Type A : Fig.C.1.11

Type B: Alternative

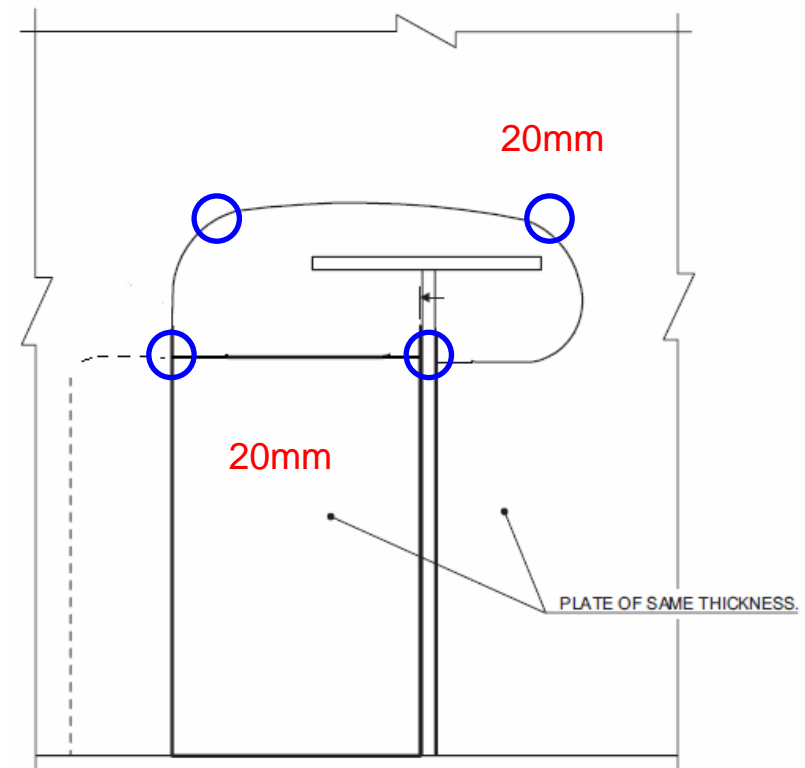
- If the hot spot stress is equivalent by the increased web/collar thickness, Type B should be accepted as an alternative design to Type A (Fig.C.1.11).
